NORTHGATE END 3/18/0432/FUL RESPONSE TO PLANNING COMMITTEE'S COMENTS 20 JUNE 2018

This is a response to the comments raised by the Committee on 20 June 2018 with regards to planning application Reference 3/18/0432/FUL.

5. The proposed hours of use of the car park

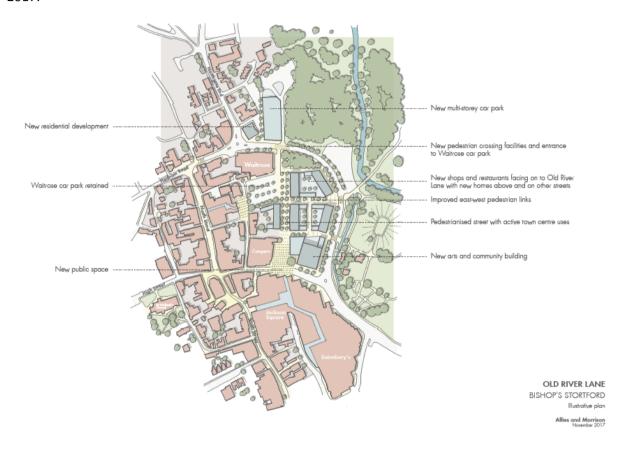
Members noted that the recommended hours of use didn't allow for the car park to support the upcoming development at Old River Lane.

The applicant agrees with Members comments on the need for the car park to support to the Old River Lane development. It would be appropriate to address any operational details of the proposed car park, including the opening hours, in a management plan to be agreed with the Planning Authority. However extending the closing time (no entry) to midnight would be a reasonable compromise.
